Dear Editor and Reviewers,

We hope that our replies convincingly demonstrate the novelty and integrated nature of this study. This research constructs a four-stage seismic resilience assessment framework based on the dynamic process of water distribution networks (WDNs) responding to earthquake disasters, and carries out refined and comprehensive assessment of WDNs seismic resilience. This approach aligns closely with the aims and readership of NHESS. We believe that this approach aligns closely with the aims and readership of NHESS.

Figure 7. Spatial distribution of WDNs component importance (The darker the color, the higher the importance of the component. For the identification of key pipelines, it is assumed that the current seismic fortification intensity is X)

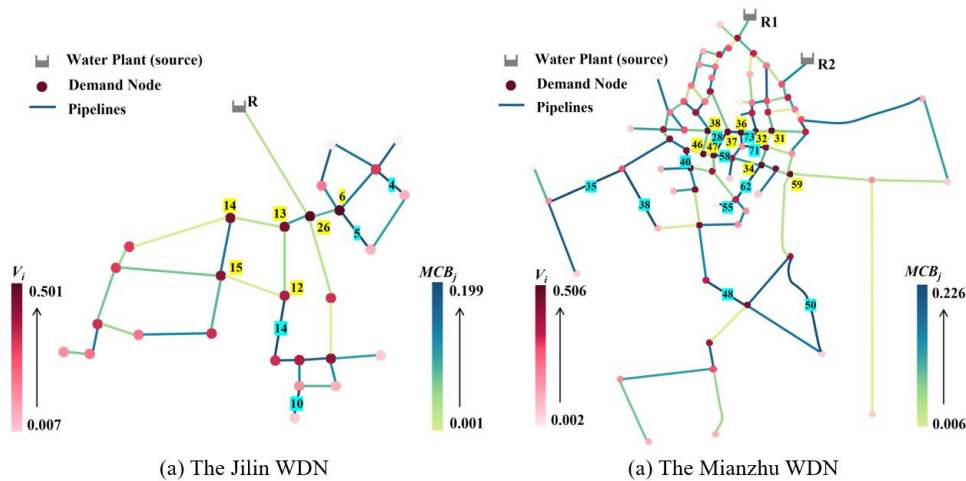
43) Fig.7: This is completely counterintuitive. Nodes at the periphery shouldn't be that important. Am I missing something? It would help when you write in the caption again what V_i and MCB_j are. The “seismic fortification intensity” has not been defined.

We sincerely appreciate the reviewer’s careful and constructive comments. Indeed, edge nodes should not be assigned such high importance. The authors have revised the calculation formula for critical nodes in the revised manuscript. The spatial distribution map of the final critical components is presented as follows:

The term “seismic fortification intensity” represents the local seismic fortification intensity of the research area, which has been annotated in the figure caption.

Figure 11. Water supply satisfaction rate under different earthquake magnitudes

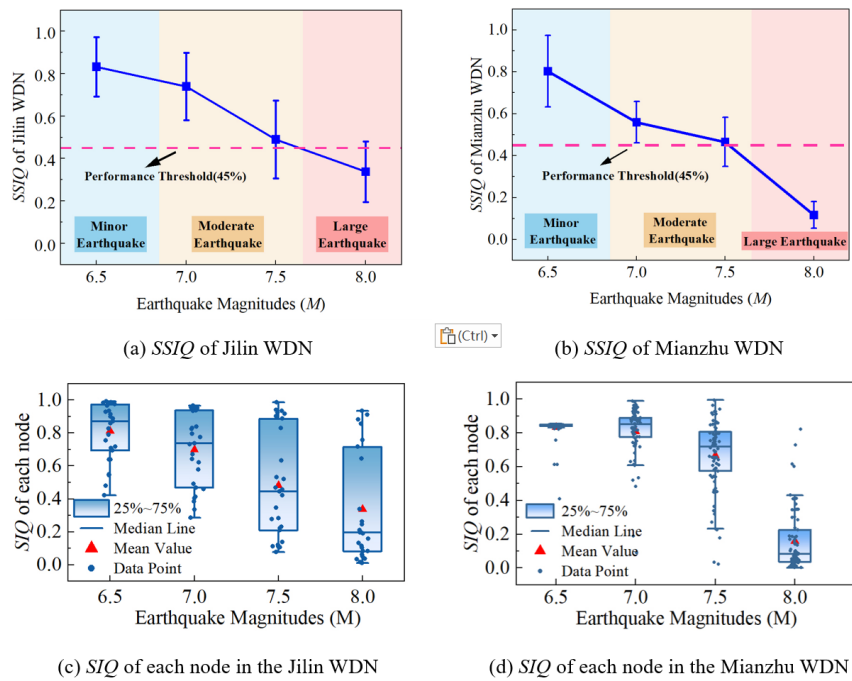
49) Fig.10: text in figure is too small.

We sincerely appreciate the reviewer's careful and constructive comments. We have adjusted the font size of the text in the figure, and the revised figure is presented below:

Fig. 12 The WDNs’ recovery time and recovery rate under different magnitudes

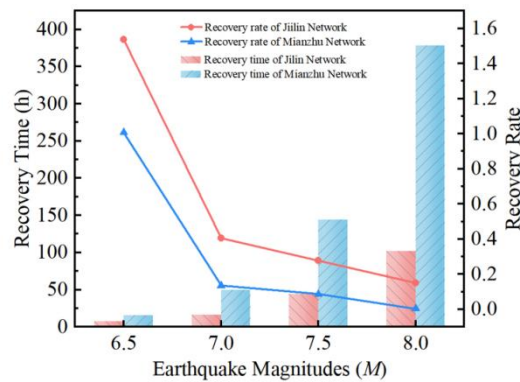
51) Fig.11: suggest to color code the lines like the bars

We sincerely appreciate the reviewer’s careful and constructive comments. We have revised the figure, and the updated version is presented below.

Fig. 13 Mean performance recovery curves and one standard deviation error bars of WDNs under different magnitudes

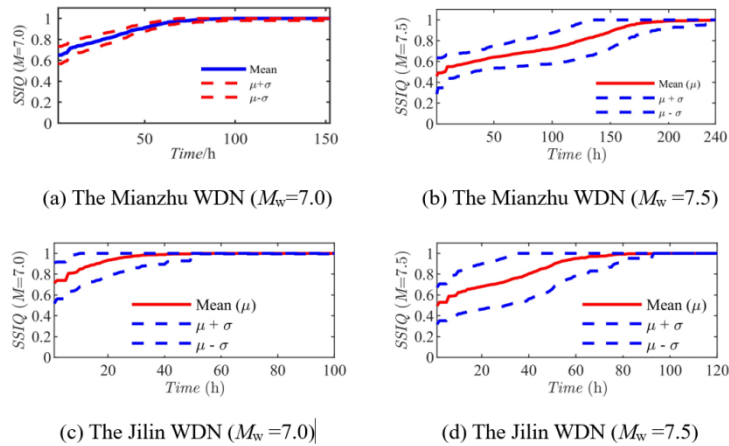
52) Fig.12: does it make sense that the μ +sigma curves all go beyond 1?

We sincerely appreciate the reviewer’s careful and constructive comments. Since the standard deviation σ characterizes the dispersion degree of data and has no inherent upper or lower bounds, the sum $\mu + \sigma$ may exceed 1 when the mean value μ is close to 1 (e.g., $\mu = 0.95$) while $\sigma = 0.1$. As the SSIQ is a normalized performance metric, its error range ($\mu \pm \sigma$) should theoretically be constrained within the boundary of 0 and 1. Accordingly, we have reprocessed the raw data and truncated the error range strictly within the interval [0, 1]. The revised figure is presented below.
